Ffridd Rasus Landfill

Areas 1 & 3

EPR/GP3330BY

GWYNEDD COUNCIL VARIATION PROPOSAL

Ffridd Rasus Landfill - Proposed Compliance Limits for Ammoniacal Nitrogen at Boreholes BH19A/C

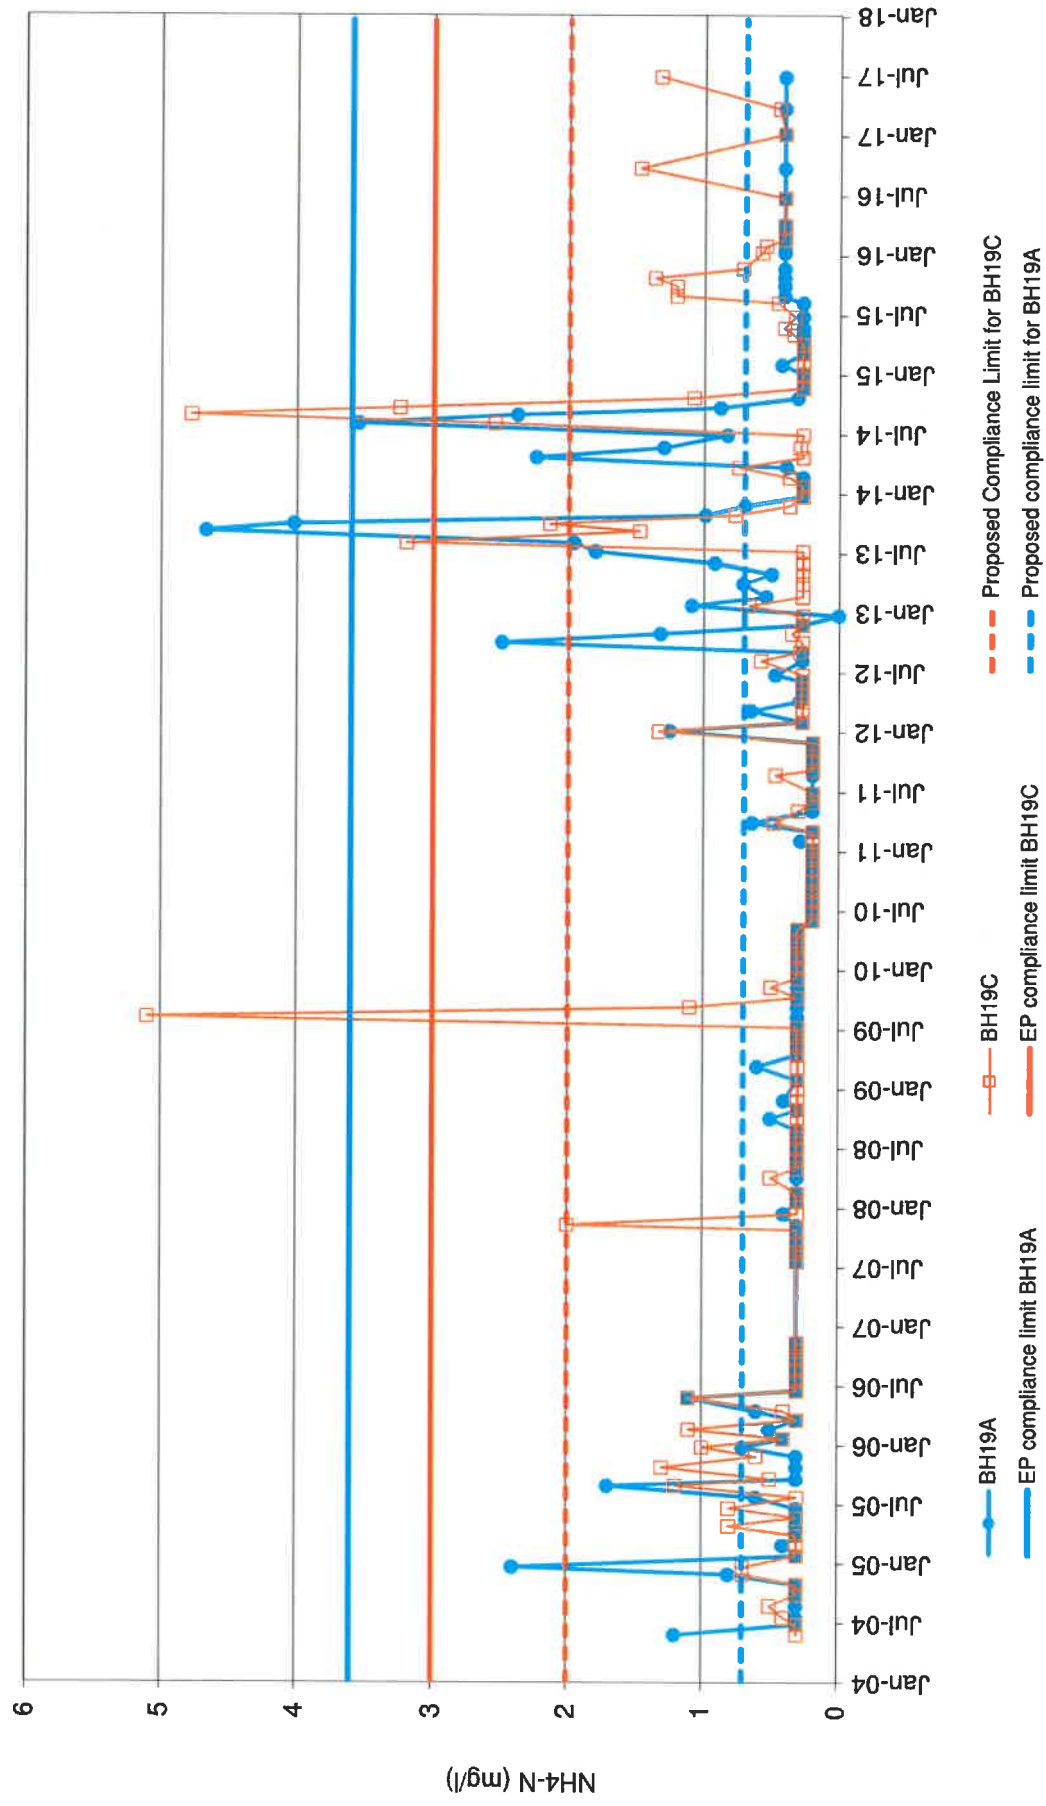
Borehole	Chloride	Ammoniacal-nitrogen
BH19A	<p>Compliance limits suspended pending the results of additional monitoring as required under EP condition 4.2.1 (b). Current elevated concentrations are not directly linked to the Area 2 landfilling activity, but are a result of a separate pollution incident from site capping (which resulted in the release of a saline slug).</p> <p>Monitoring to be continued and compliance limits derived once there is no impact from the saline slug.</p>	<p>Data review: historical concentrations show variability and a number of elevated spikes. Since 2013 concentrations dropped but with some variability with a number of elevated spikes. Concentrations have been below 0.5 mg/l since 2015.</p> <p>Proposed compliance limit: reduce compliance limit from 3.6 to 0.7 mg/l and set control level of 0.6 mg/l (review annually as part of AERs).</p>
BH19B	Same as BH19A	<p>Data review: historical concentrations show variability and a number of elevated spikes. The elevated spikes have become less frequent and have been below 0.6 mg/l since mid-2013.</p> <p>Proposed compliance limit: reduce compliance limit from 1.5 mg/l to 0.7 mg/l and set control level of 0.6 mg/l (review annually as part of AERs).</p>

Ffridd Rasus Landfill - Proposed Compliance Limits for Chloride at Boreholes BH21B

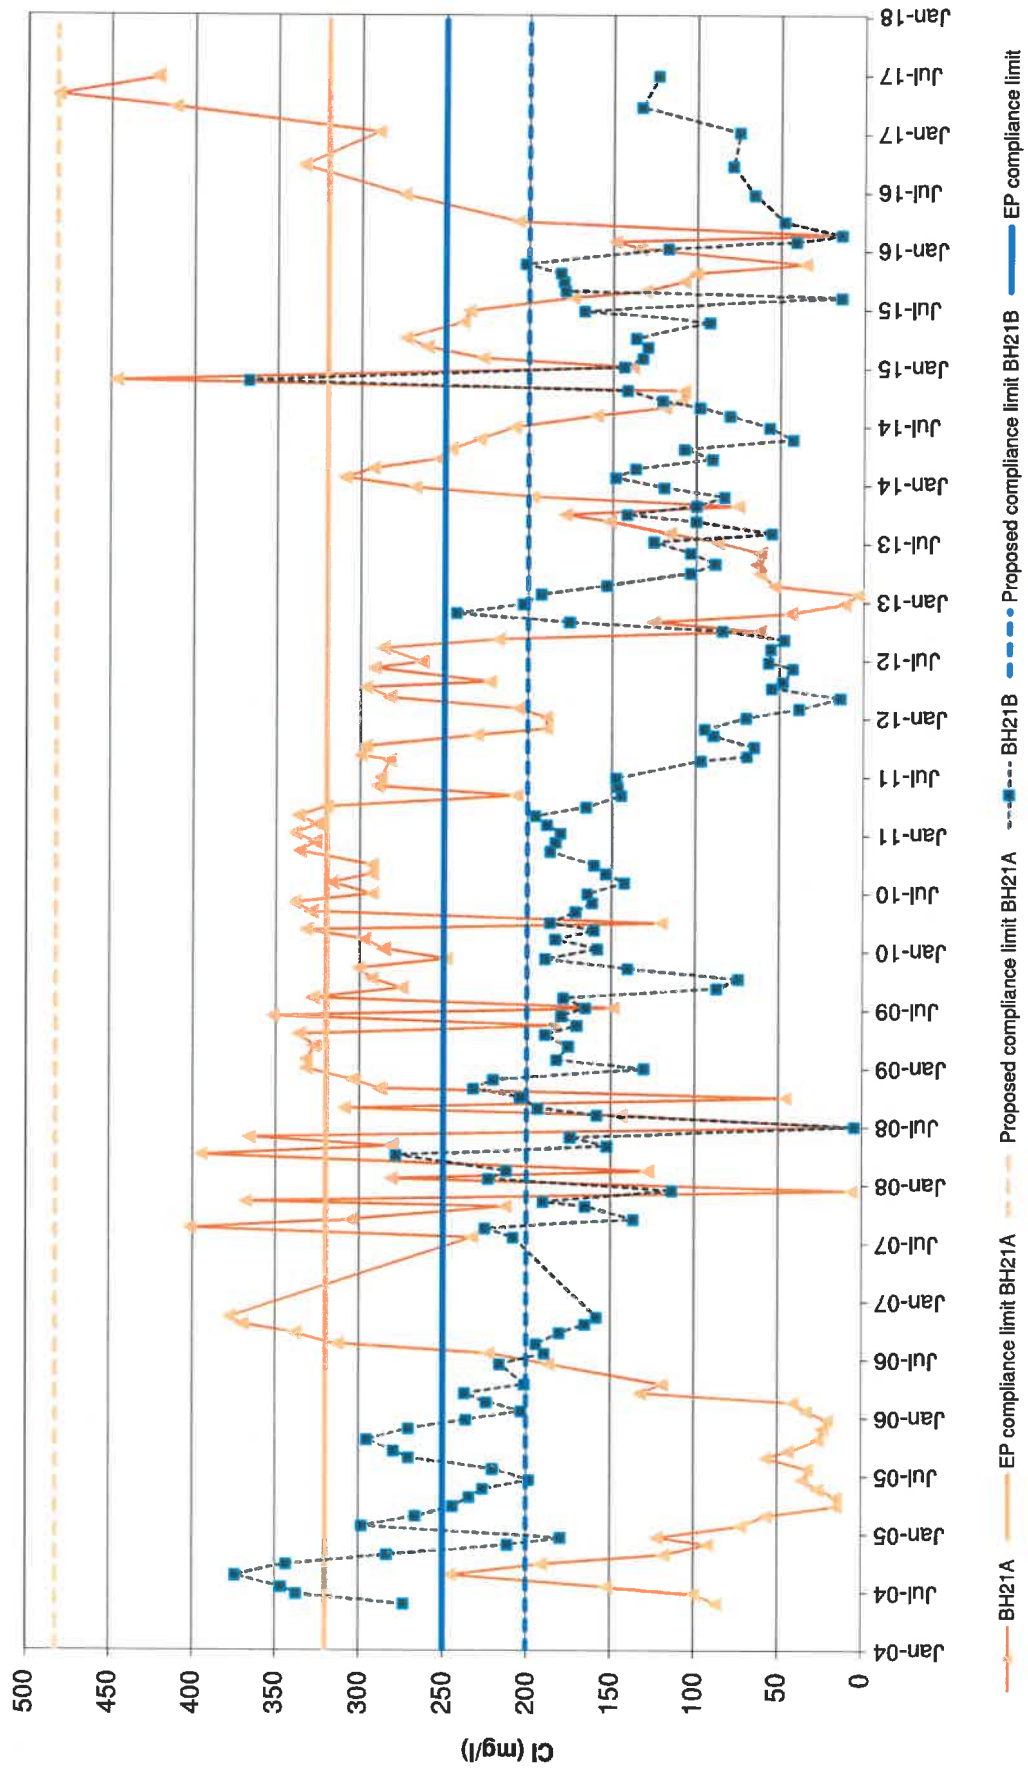
Borehole	Chloride	Ammoniacal-nitrogen
BH21B	<p>Data review: concentrations have shown a downward trend since 2004 and have been below the compliance limit (250 mg/l) since 2006 except for two spikes. More recently concentrations have dropped below 200 mg/l except for a small number of spikes.</p> <p>Proposed compliance limit: reduce compliance limit from 250 to 200 mg/l to reflect the improvement in groundwater quality (review annually as part of AERs).</p>	<p>Data review: concentrations are lower than the historical elevated concentrations in 2011/2012. Concentrations show variability with several periods of increasing and then decreasing concentrations but with an overall downward trend. More recently concentrations have dropped below 40 mg/l. Additional data is required to confirm the recent drop in concentrations.</p> <p>Proposed compliance limit: reduce EP compliance limit for from 80 mg/l to 60 mg/l allowing for the observed variability in concentrations (review annually as part of AERs).</p>

Ffridd Rasus Landfill - Proposed Compliance Limits for Ammoniacal Nitrogen at Boreholes BH21A/B

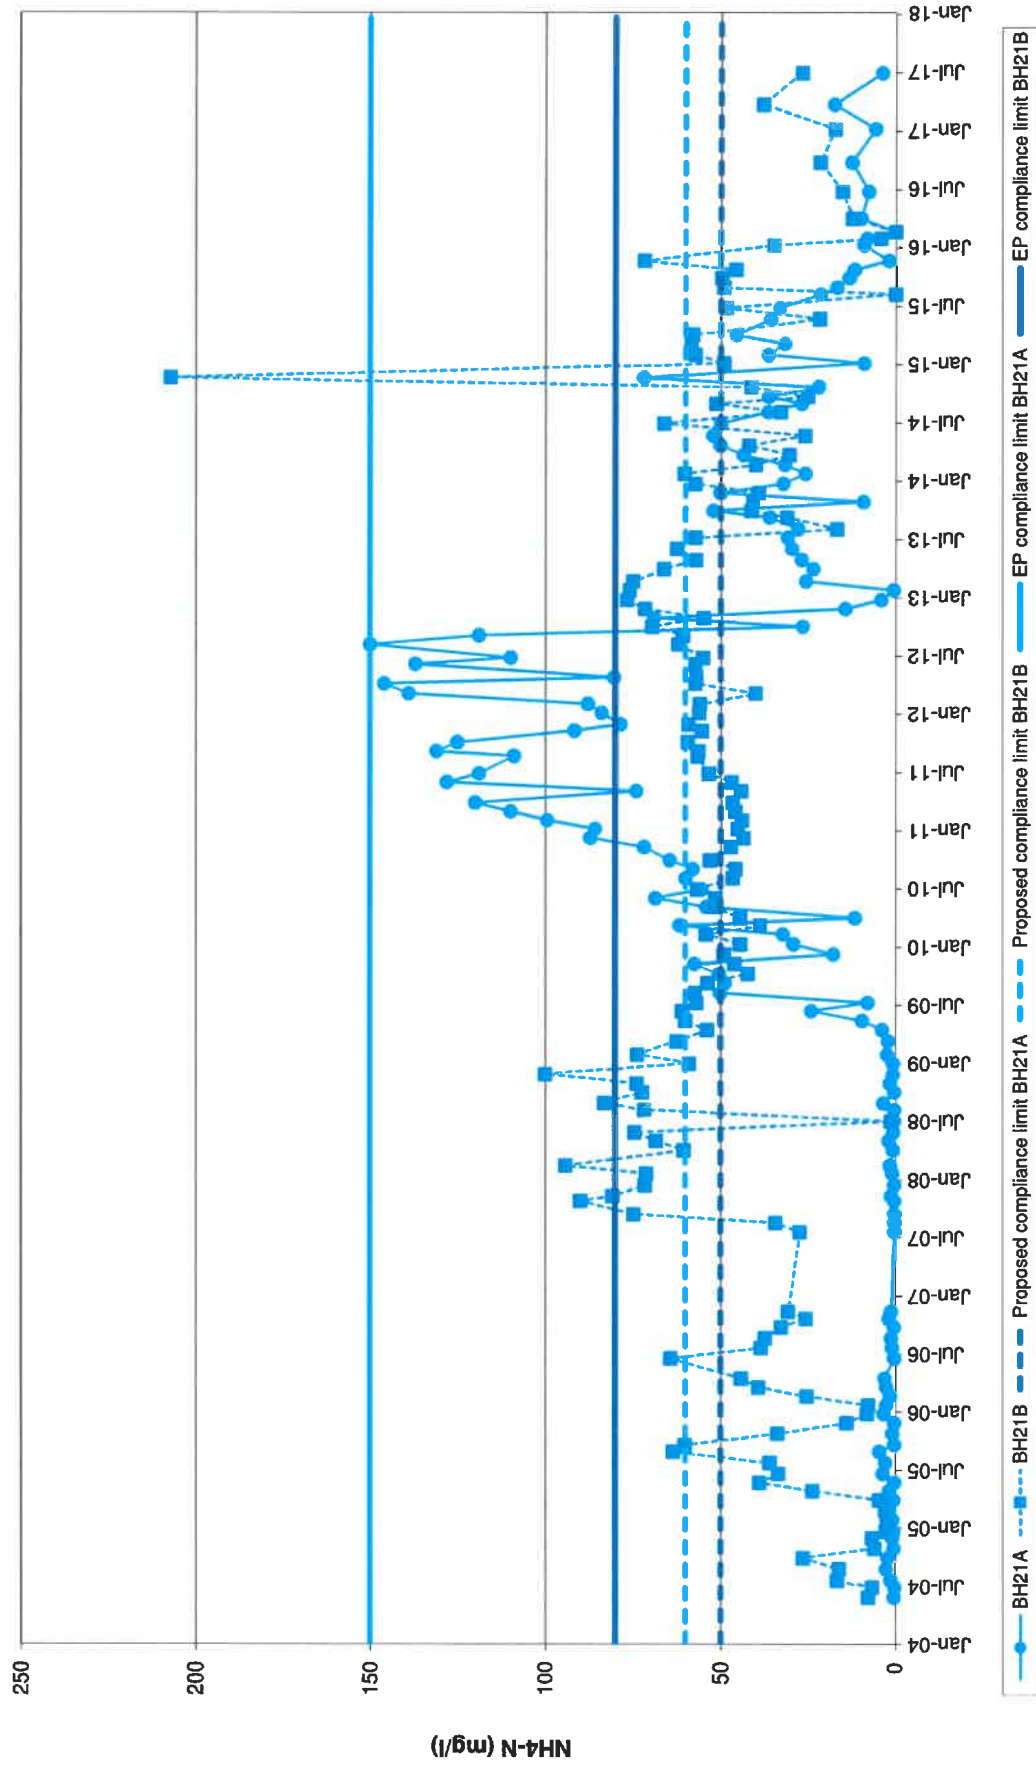
BH21A	<p>Data review: as discussed above the recent increase above the compliance limit may be due to: leakage from Area 3 (unlikely) or impact of leachate plume migration from Area 2 at depth (more likely). Concentrations appear to have peaked in May 2017 (482 mg/l).</p> <p>Proposed compliance limit: increase temporarily compliance limit to 482 mg/l, continue monitoring and review as part of the 2017 AER.</p>	<p>Data review: concentrations are lower than the historically in 2011/2012 and show variability with several periods of increasing and then decreasing concentrations but with an overall downward trend. Concentrations have recently dropped below 20 mg/l. Additional data is required to confirm the recent drop in concentrations.</p> <p>Proposed compliance limit: reduce EP compliance limit for from 150 mg/l to 50 mg/l allowing for the observed variability in concentrations (review annually as part of AERs).</p>

Ffridd Rasus Landfill - Proposed Compliance Limits for Chloride at Borehole BH29

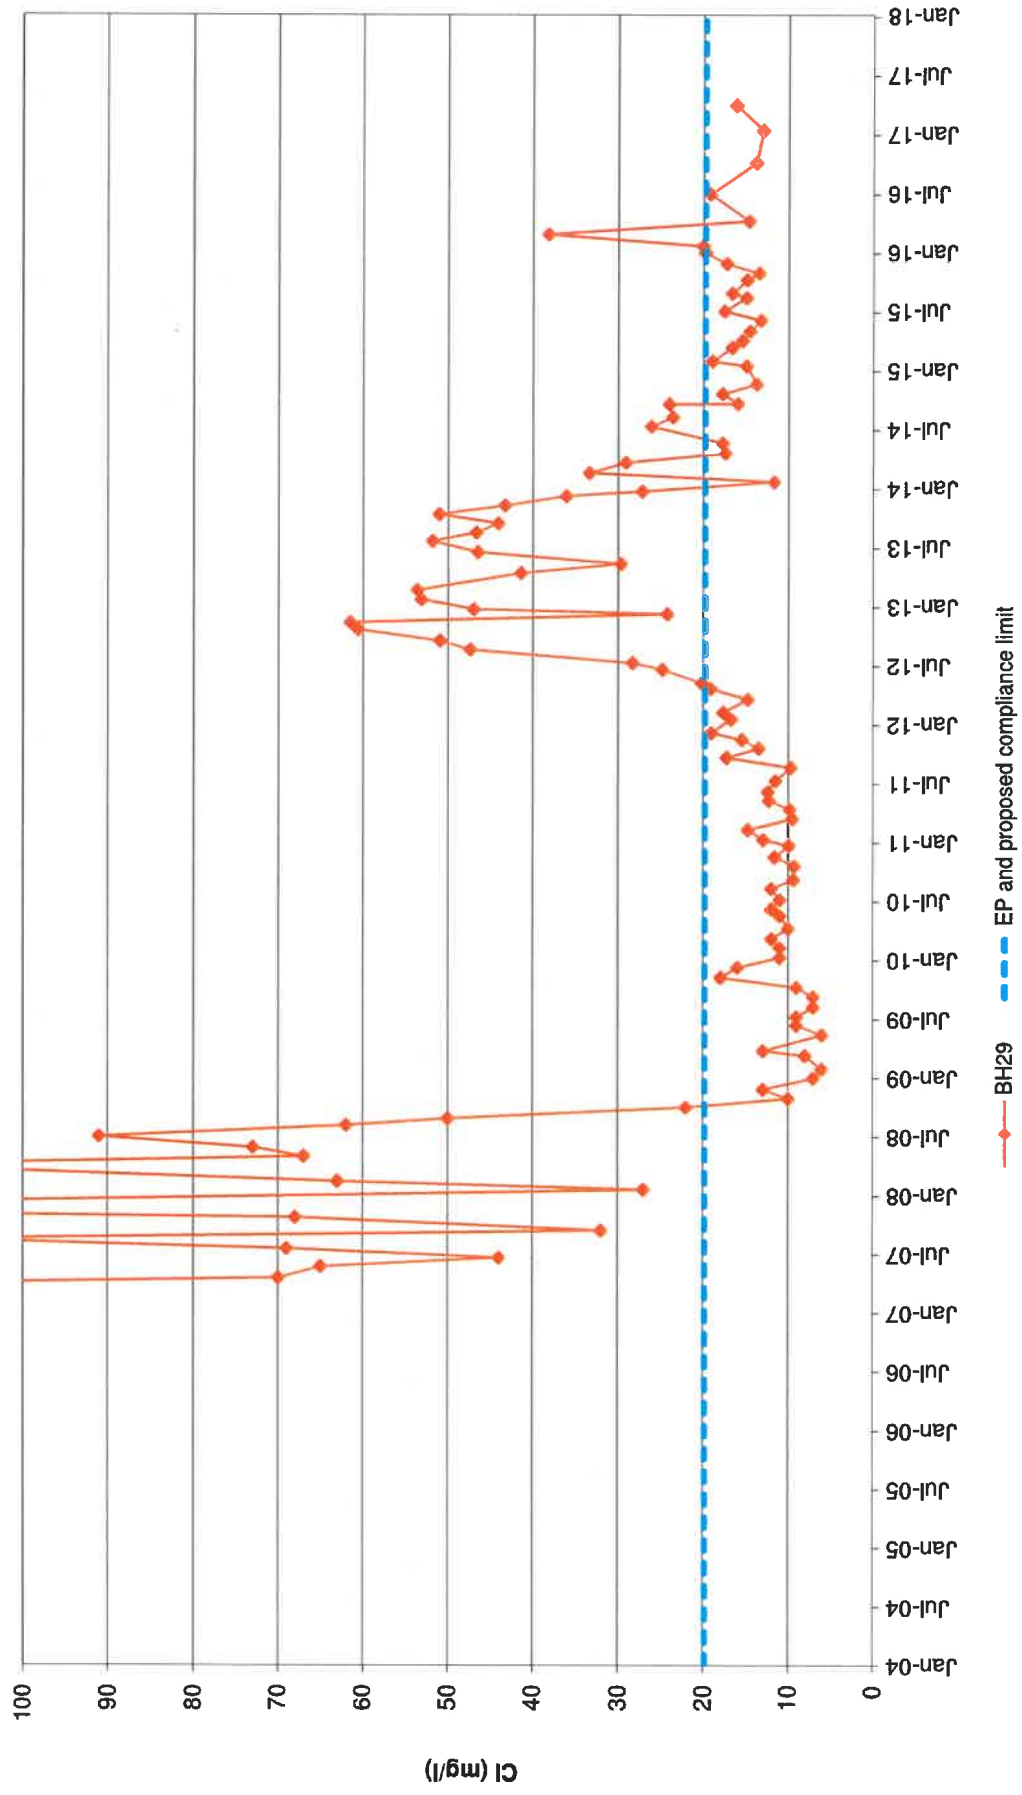
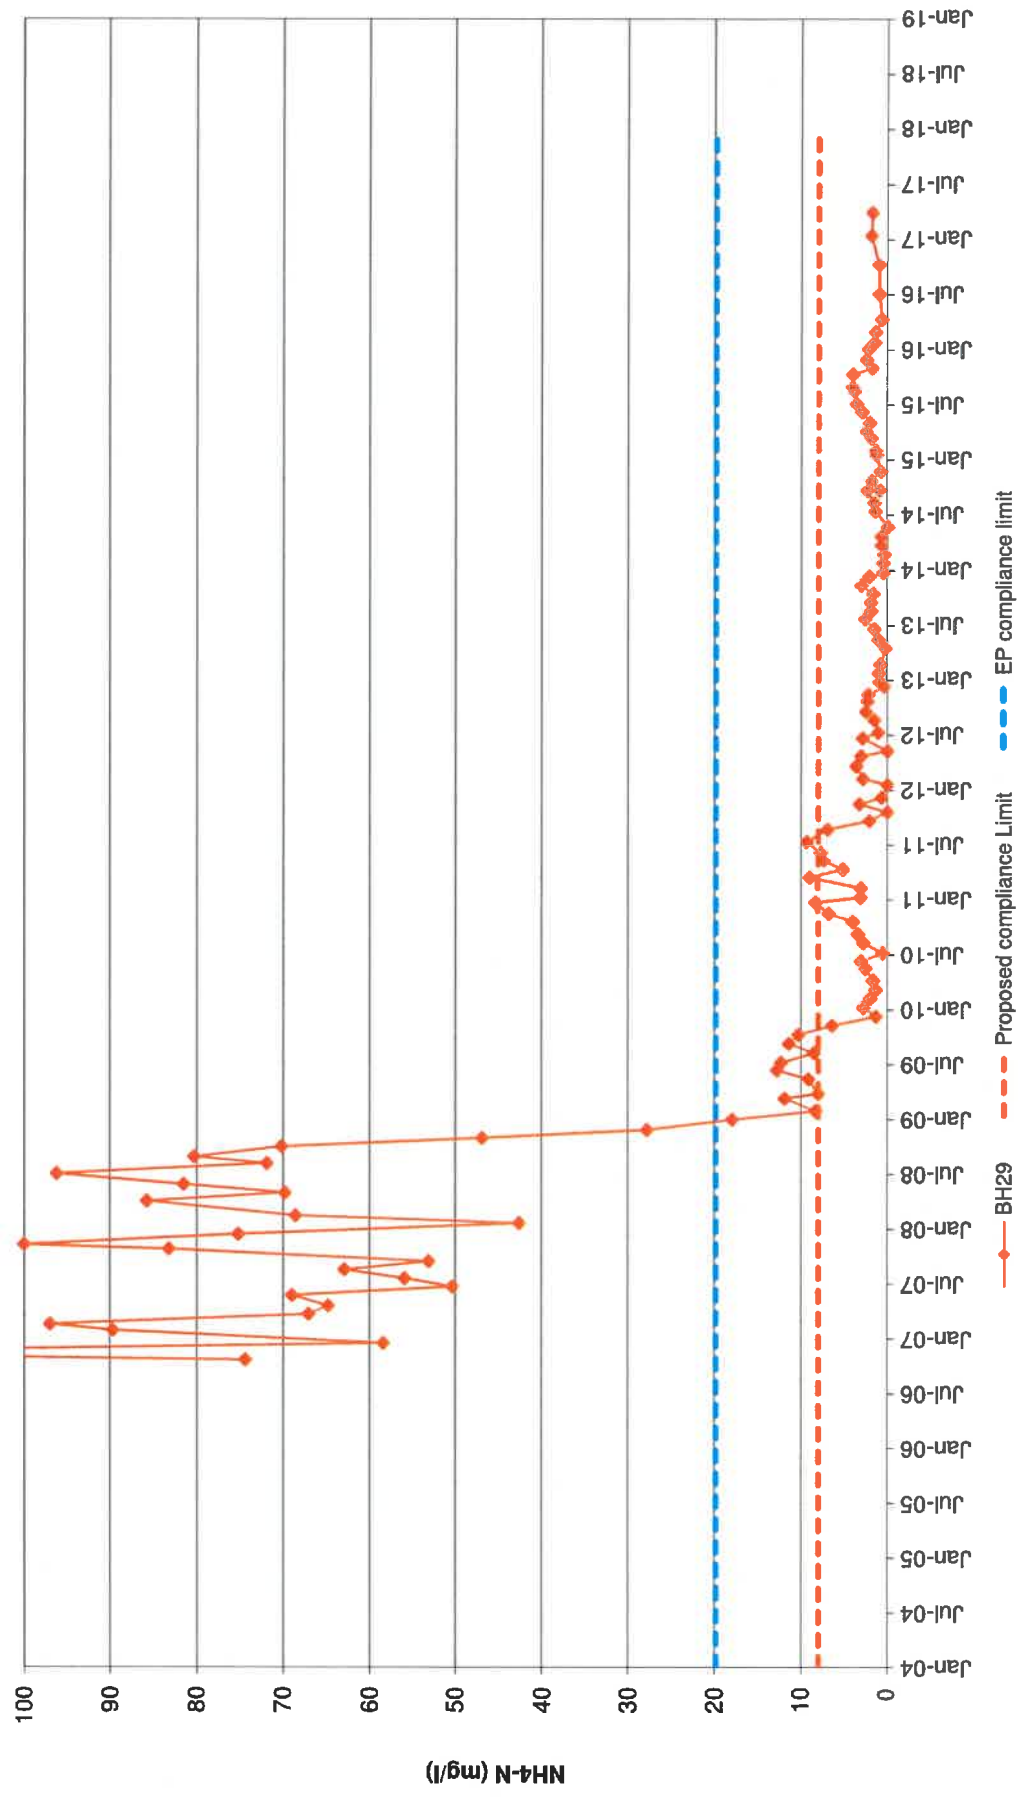
BH29	<p>Data review: downward trend between 2012 and 2014. Concentrations have remained below the compliance limit (19.8 mg/l) since end of 2014 except for one elevated spike.</p> <p>Proposed compliance limit: no change (review annually as part of AERs).</p>	<p>Proposed compliance limit accepted by NRW (15/08/17)</p>
BH30	<p>Proposed compliance limit accepted by NRW (15/08/17)</p>	<p>Data review concentrations show a downward trend since 2010 with a recent increase peaking marginally above the compliance limit (190 mg/l).</p> <p>Proposed compliance limit: no change (review annually as part of AERs).</p>
BH31	<p>Data review: since the end of 2009 concentrations vary between 41 and 138 mg/l and only exceeded the compliance limit (130 mg/l) on a small number of occasions.</p> <p>Proposed compliance limit: no change (review annually as part of AERs).</p>	<p>Data review: concentrations have ranged historically between 50 and 100 mg/l with the highest concentrations observed in 2012/2013. Since 2013 concentrations have remained below 80 mg/l dropping recently (2016/early 2017) to 54 mg/l. Additional data is required to confirm the recent drop in concentrations.</p> <p>Proposed compliance limit: reduce EP compliance limit for from 100 mg/l to 80 mg/l allowing for the observed variability in concentrations (review annually as part of AERs).</p>
